AIRPORT LAND USE COMMISSION RIVERSIDE COUNTY AGENDA

09-AFC-6

Thursday 9:00 a.m., June 10, 2010

- 2.1 ZAP1015FL10 – Riverside County Economic Development Agency, for Riverside County Regional Park and Open-Space District – (Representative: Jill Efron/RHA Landscape Architects Planners Inc.) - Rancho Jurupa Sports Complex (Amended proposal) – A park with soccer fields, including lighted soccer fields, picnic shelters, playground with play structures, restroom/concession building, and storage building, on a 36.54-acre site located northerly of Crestmore Road and 46th Street, westerly of Loring Ranch Road, and southerly of Flabob Airport in the unincorporated Riverside County community of Rubidoux. ALUC Staff Planner: Russell Brady at (951) 955-0549, or e-mail at rbrady@rctlma.org. or John Guerin at (951) 955-0982, or e-mail at jguerin@rctlma.org.

Figure 5
Blythe Airport Estimated
Future Right Hand Turn Pattern
for Runway 26
(Approximately 80% of Traffic)

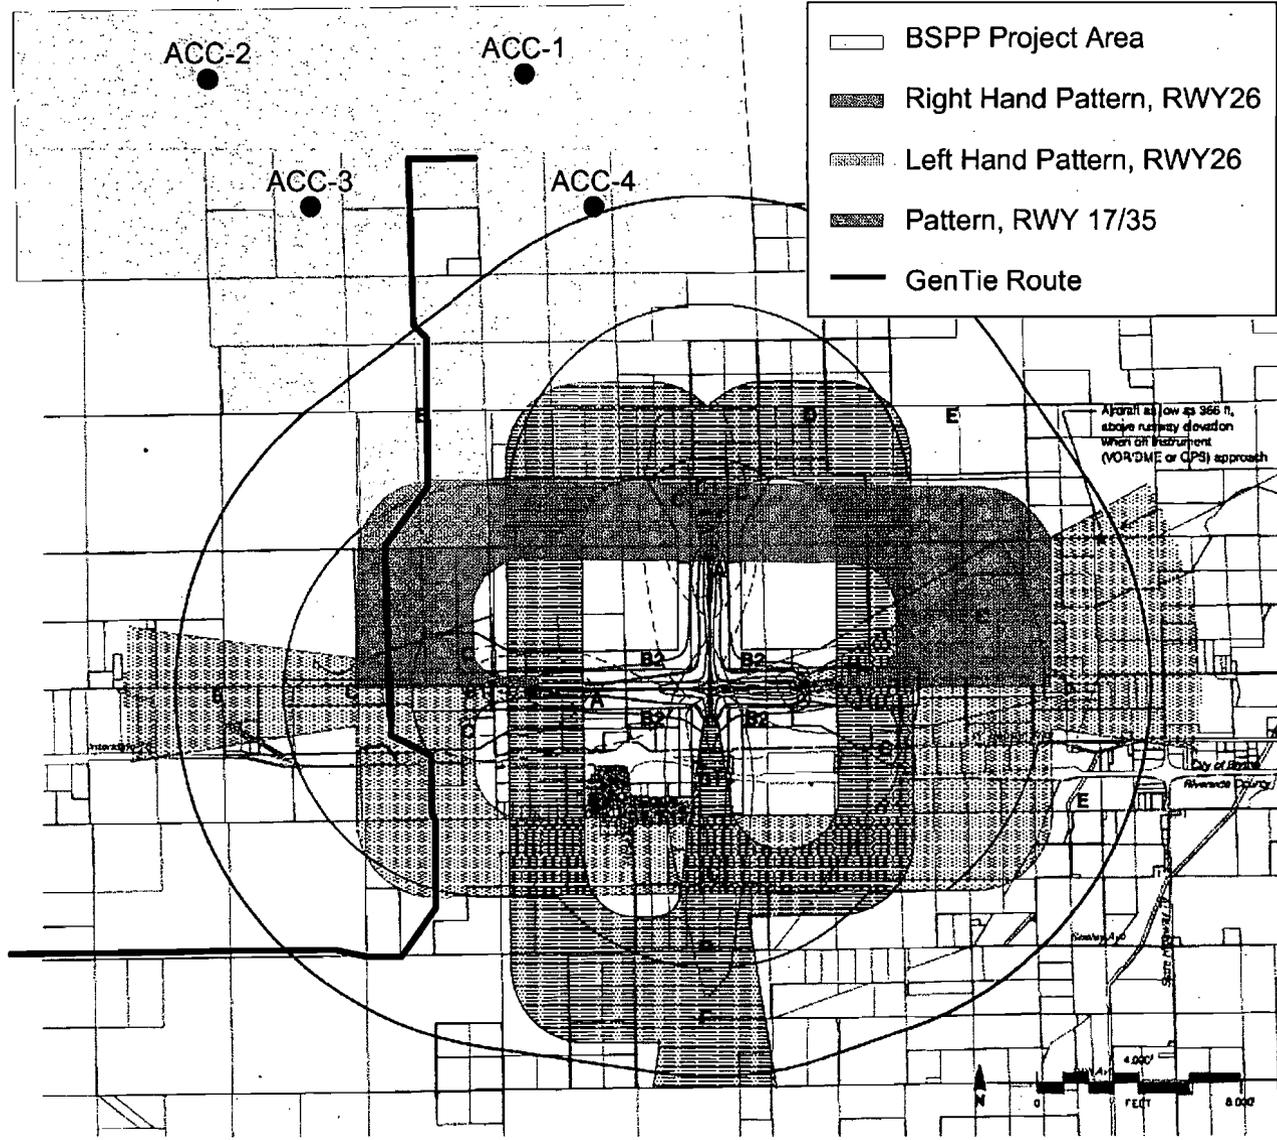
Greater use of Runway 17-35 could ~~would~~ increase the likelihood of flyover of the Unit #4 power block. However, as depicted on Figure 5 of the applicant's response dated May 27, 2010, conversion of Runway 26 to a right-hand pattern would not result in flyover of ACC-4 for the majority of aircraft (presuming that the right-hand pattern would be a mirror image of the left-hand pattern), although it would result in flyover of transmission lines farther to the south.

Blythe Solar Power Project
 Figure 7
 Analysis of Postulated Reflection
 Scenario for a Reflection
 Along the HCE Tube

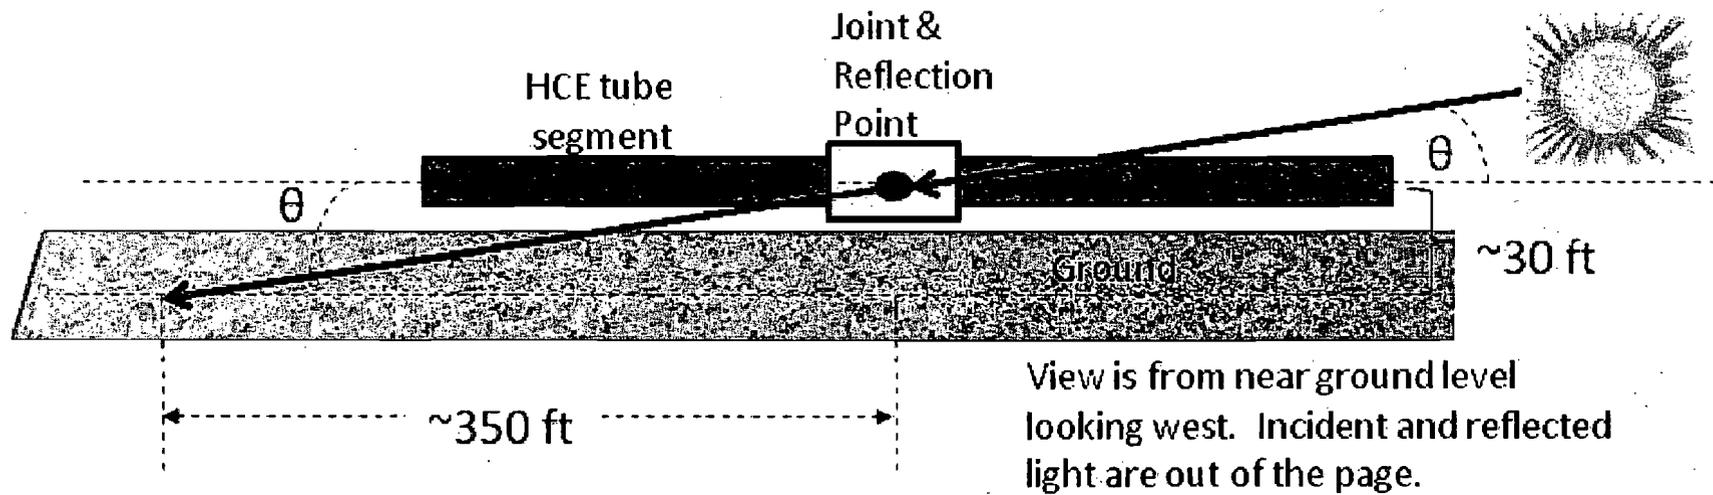
At 6:00 AM PDT on June 21, the solar elevation angle (θ) above the horizon is 5 degrees and the solar azimuth (measured clockwise from north) is 65°. Snell's law requires the reflected light to form the same angle with the normal to the tube (directed on an azimuth of 90°, or due east). For a 65° incident azimuth, the reflected ray will be at an azimuth of 155°. Thus, a bearing 180° opposite the reflected ray, or 335° from the pilot's viewpoint, would be the view bearing along which the glint would be observable (Figure 6). As the sun's azimuth moves south in advance of or past the summer solstice, the reflected ray will decrease from an azimuth of 155° near sunrise on the solstice to an azimuth of 90° at the equinox on either side of the solstice. For a given sun elevation and azimuth angle, a series of potential reflection points occur along the view bearing opposite of the azimuth of the reflected ray, corresponding to each mirror trough along the bearing. However, the intensity of each succeeding reflection along the view bearing will decrease as the square of the distance from the pilot. This, only the nearest reflection points need to be considered.

departure angle of 5° below horizontal. The azimuth of the reflected ray will be 65° south of the normal (east), or on an azimuth of 155°. As the HCE tube will be approximately 30 ft above the ground at its maximum (the actual height varies with the orientation of the mirror), trigonometry indicates that the reflected ray will strike the ground approximately 350 ft from the reflection point, measured along the HCE tube. See Figure 7. As the reflected ray is directed at a projected horizontal angle of 65° from the HCE tube in a downward direction, the reflected ray will most likely be intercepted by the adjoining parabolic mirror support structure before it can reach the ground. As the sun rises during the day, the solar elevation angle will increase, as will the reflection angle below the horizontal. Beyond a certain solar elevation (and resultant solar azimuth), it would not be possible for the horizontal projection of the ray to cross the path of the pilot in the pattern on final approach due to Snell's Law.

Figure DR-ALT-43-1 BSPP Alternative Reconfigured by Applicant

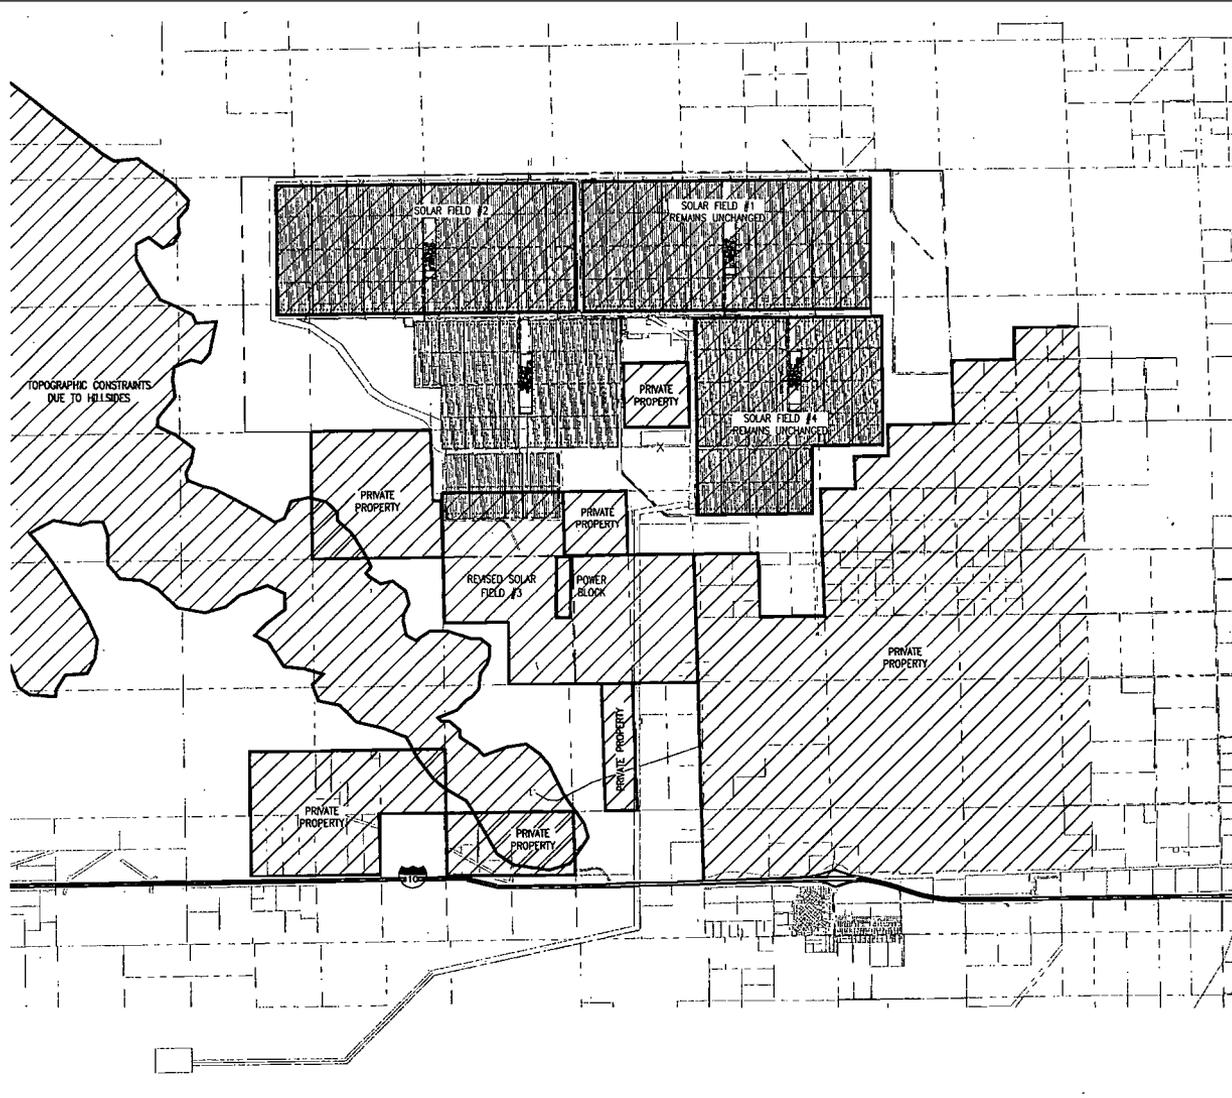
Based on the request in DR-ALT-43 to establish a revised configuration that would reduce effects on the most sensitive biological resources, PVSI has conducted additional siting analysis for this purpose. As explained above, the outlined red area is not a feasible alternative site configuration. In Figure 2, it appears that the CEC Staff uses criteria to establish a revised configuration that would allow Project facilities to be constructed outside of the BLM ROW application area. In the additional siting analysis, PVSI has used this flexibility, as well as economic and engineering criteria as described in the response to DR-ALT-41, and environmental impact criteria based on aerial photos and previous Project surveys (e.g., buffer zones surrounding the Project disturbance area), to produce a revised configuration (see Figure DR-ALT-43-1).

Engineering and economic analyses also were undertaken to evaluate alternative designs for the northwest unit (Unit 2), for the purpose of fitting the unit within the Staff's Figure 2 Reduced Project boundary. Such designs were not feasible. Specifically, PVSI evaluated a design that would relocate the southwest quadrant of the solar field to an area south and east of the original Unit 2 solar field (in space vacated by the movement of Unit 3). The resulting design has an extremely sub-optimal layout. Additional pumping auxiliaries, heat losses, and additional dead HTF mass would reduce the expected yearly efficiency by more than one percent. Please see the response to DR-ALT-41 for a thorough description of the engineering constraints that govern economic solar field design. This layout would also increase the total investment cost of the project and the daily startup time, while the anticipated electricity output and resulting revenue of the plant would be reduced by approximately 5 percent. Based on the criteria stated above, PVSI proposes that Figure DR-ALT 43-1 be used as the new "Reconfiguration Alternative" in lieu of Staff's Figure 2.

Figure 1. Location of ACC-4 Outside of the Blythe Airport Influence Area.

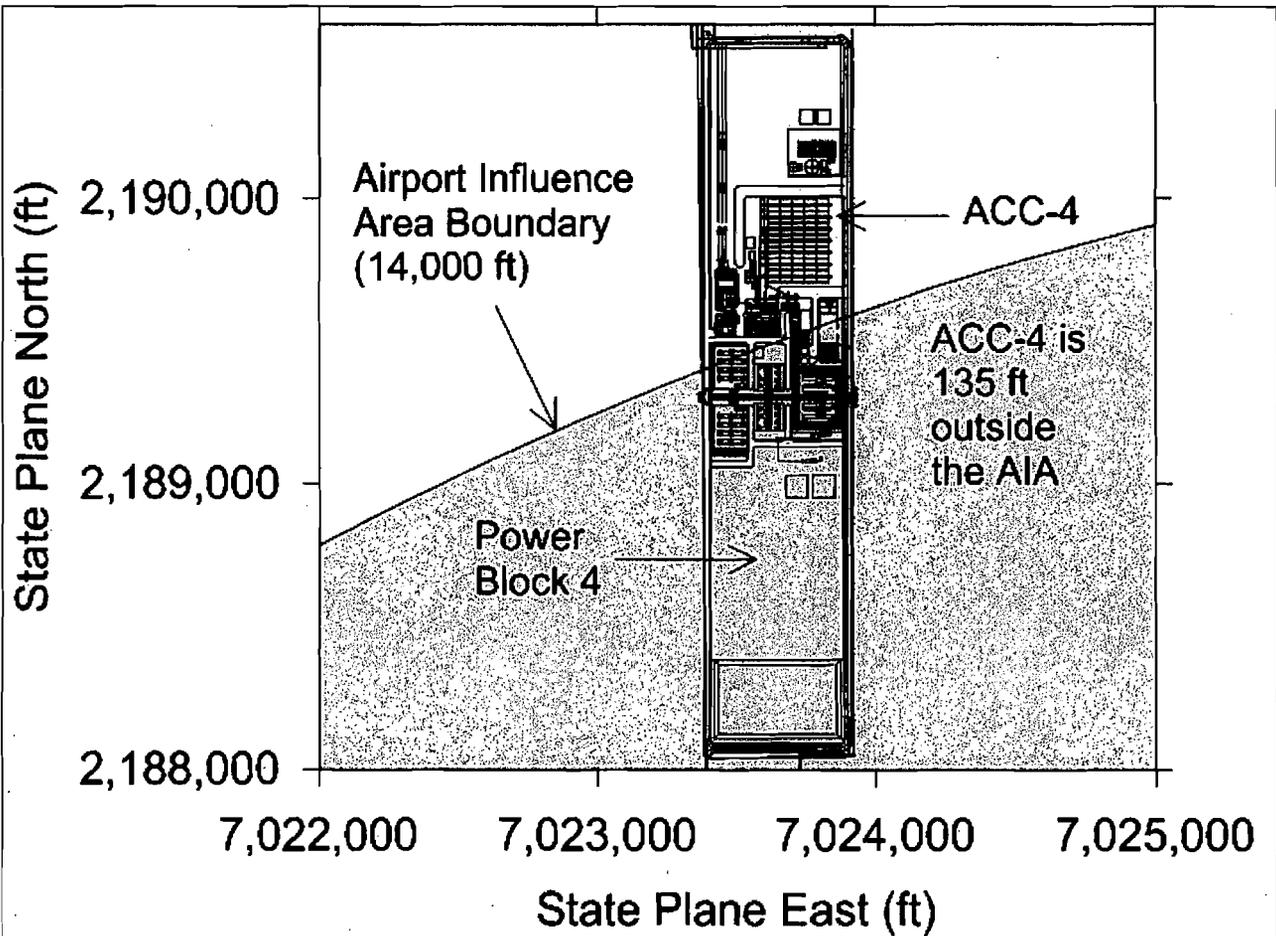
The southeastern corner of the Air Cooled Condenser 4 (ACC-4) is approximately 135 feet outside of the boundary of the Airport Influence Area. Figure 1 presents a graphic showing Power Block 4, the location of ACC-4, and the 14,000 ft limit of the AIA. The Applicant commits that the ACC-4 and auxiliary cooling tower will remain outside the Airport Influence Area in the final project plan.

Figure 2. Map Showing the Original Locations of Power Poles within the Airport Influence Area and the Compatibility Zones Filed with FAA in November 2009.

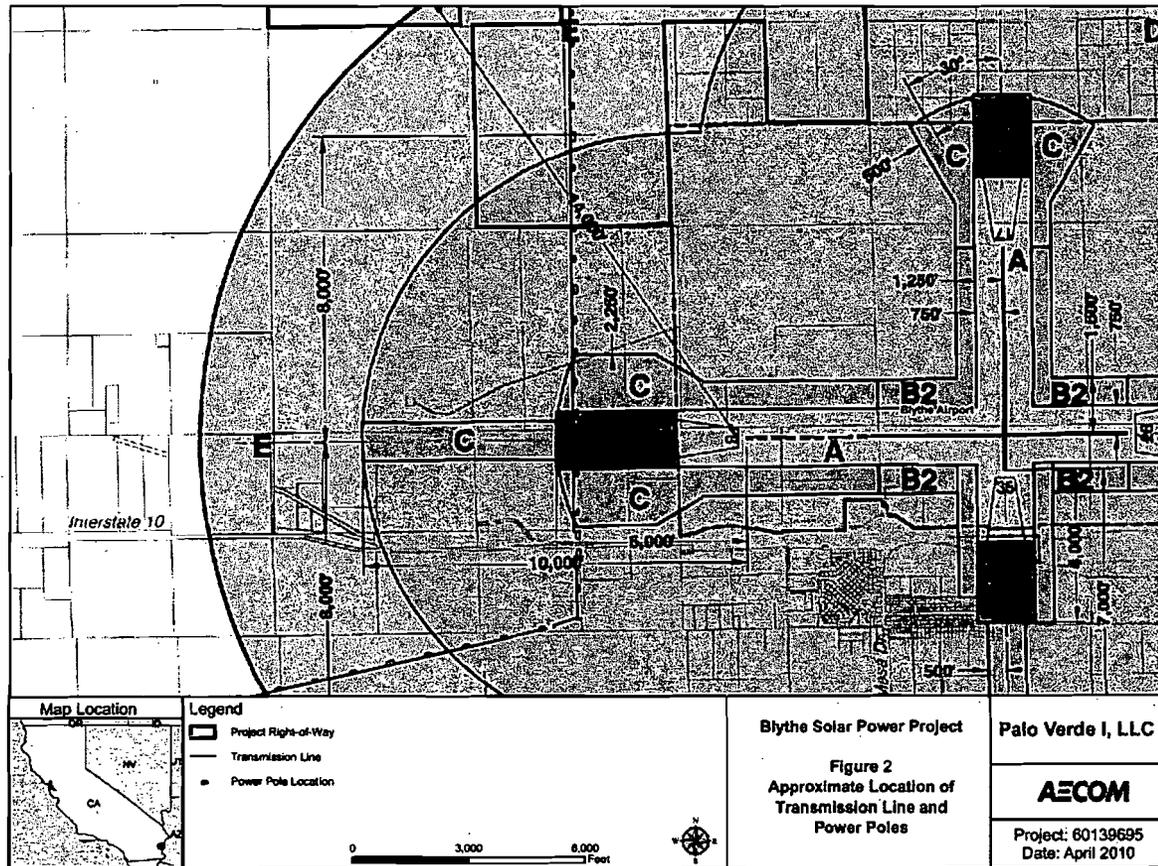
See Table 1 for a listing of each pole, their height, and the Compatibility Zone in which each is located. Figure 2 provides a map of the locations of the power poles in the separate Compatibility Zones for the Blythe Airport. Based on ALUC comments, the Applicant is modifying the Gen-Tie line route to avoid crossing Compatibility Zone B1 and commits that the new route will both avoid Zone B1 and will have transmission poles no higher than 70 ft for that portion of the revised route that crosses Zone C. Graphics of the proposed route are not available but the Applicant commits to have submitted all new FAA notifications by the May 13 Commission Meeting and will have information on specific pole locations available at that time.

Figure 3. Map Showing the Status of FAA Form 7460 Applications to the FAA.

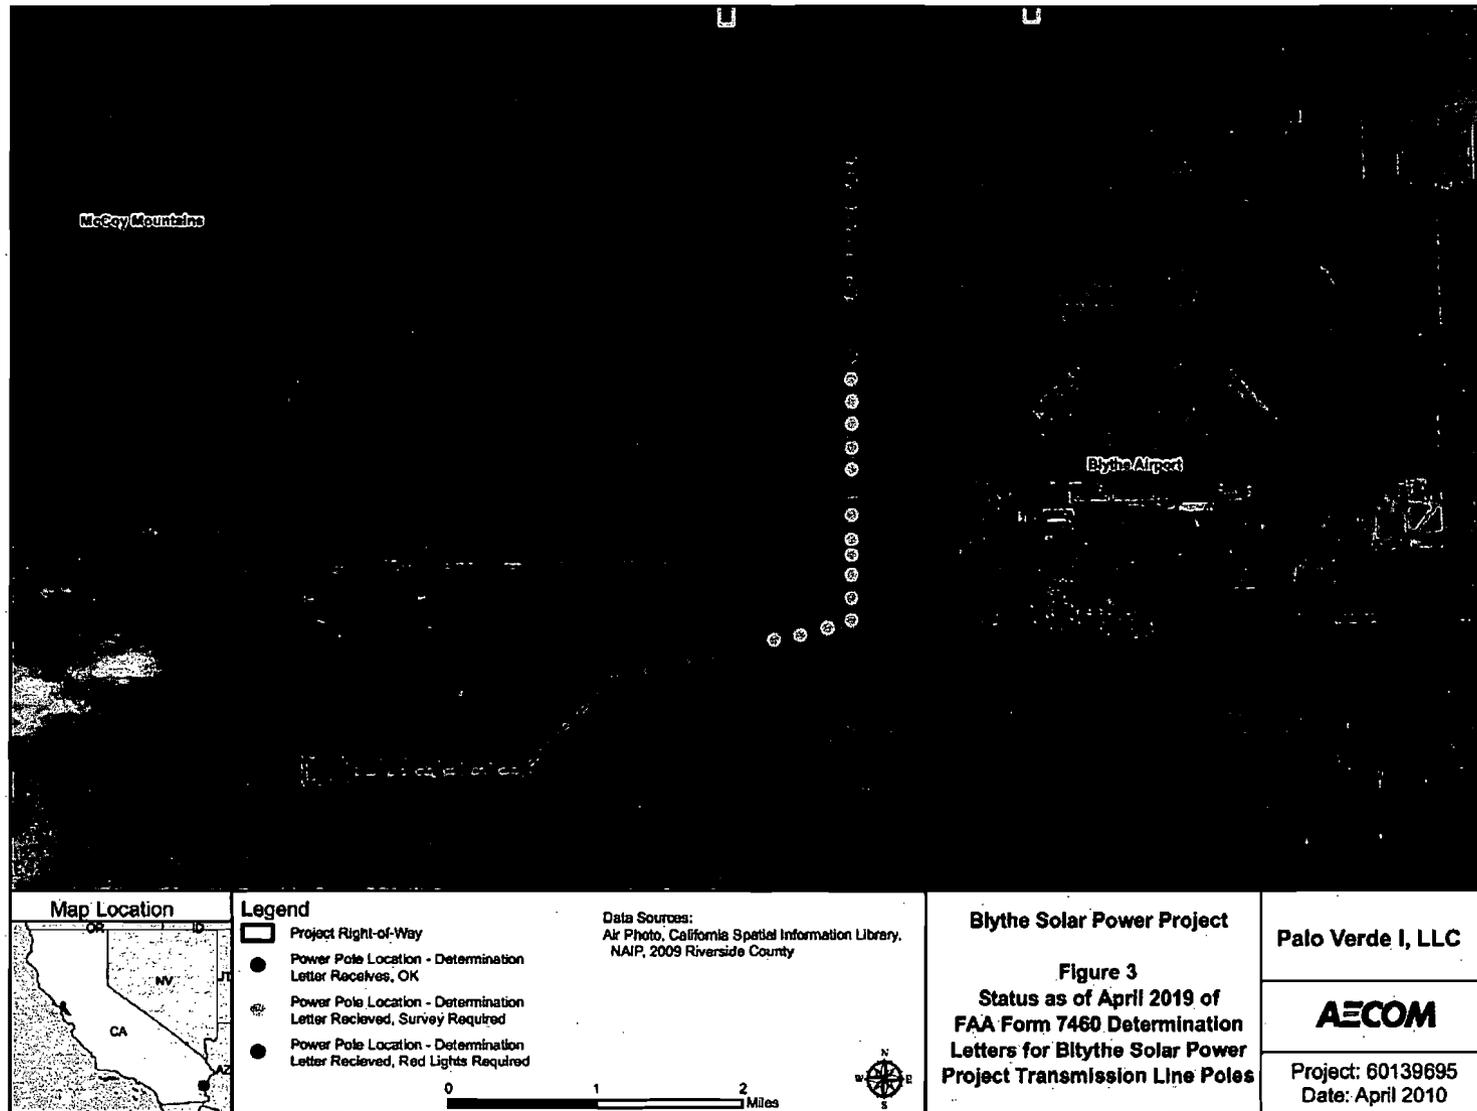
See Table 1 for a listing of each pole and its current FAA status as of 04/19/2010. Figure 3 presents a color coded map illustrating the status of each transmission line pole for which an FAA Form 7460 application has been submitted. AECOM contacted Ms. Karen McDonald of the FAA on April 14 to enquire as to the status of their review. Ms. McDonald stated that all seven review departments have finished their analyses and she is now compiling the review comments prior to issuing a determination. She cannot commit to a completion date for her review and issuance of the determinations. She did say that regulations may dictate that some of the cases will require public notice prior to final determination.

Figure 4. Submitted and Proposed New Transmission Line Corridor and Open Space within Compatibility Zone D

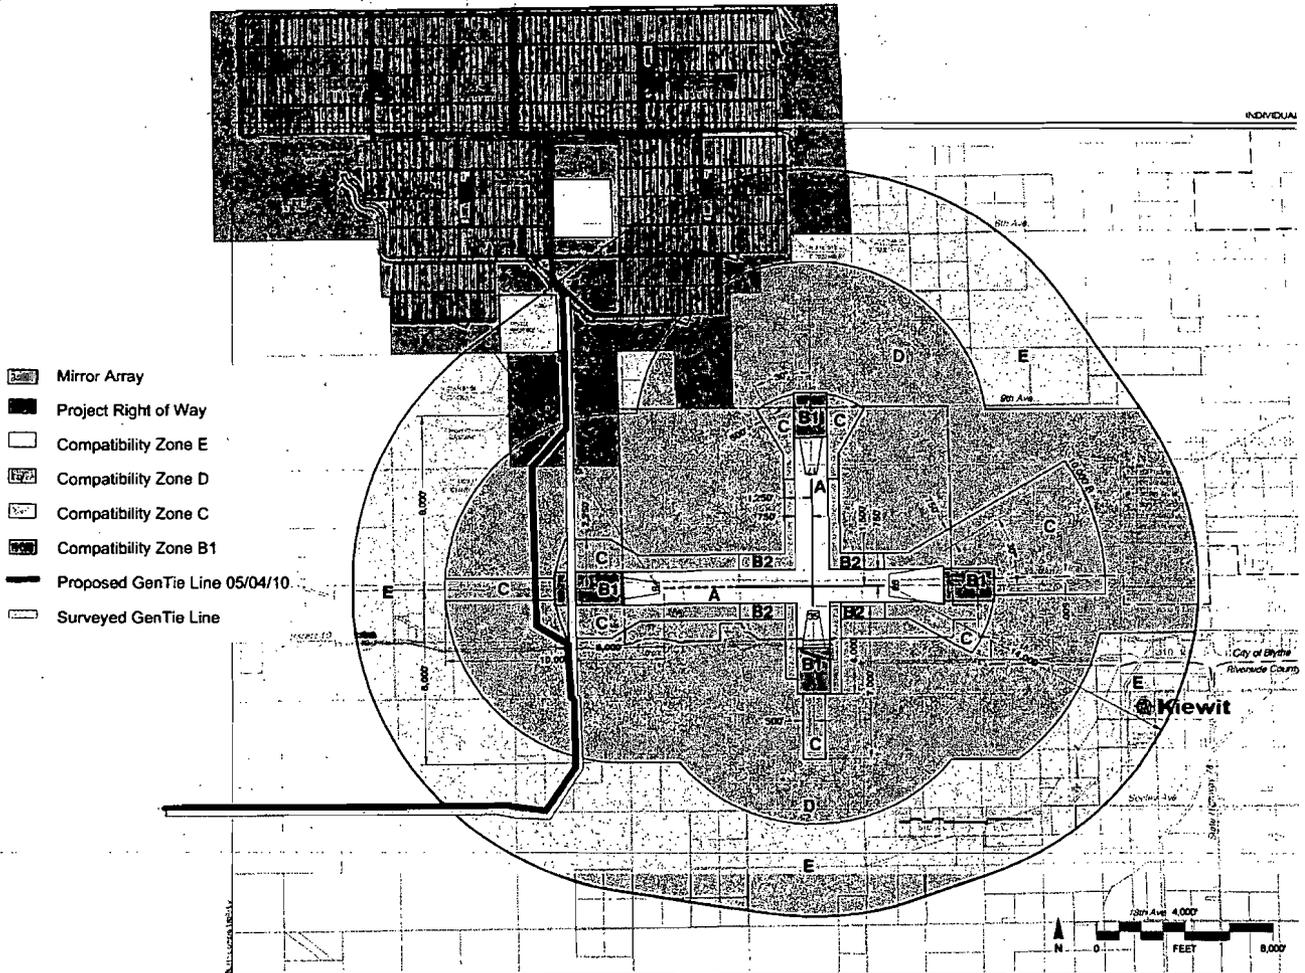
As part of the evolving design of the project plan, the Applicant is proposing to relocate that portion of the transmission line that is south of Interstate 10 and to avoid Compatibility Zone B1. The existing transmission line route and the proposed modification of that power line route are given in Figure 4. New FAA Forms 7460 will be submitted for those power poles requiring new FAA review because of the new alignment of the transmission line.
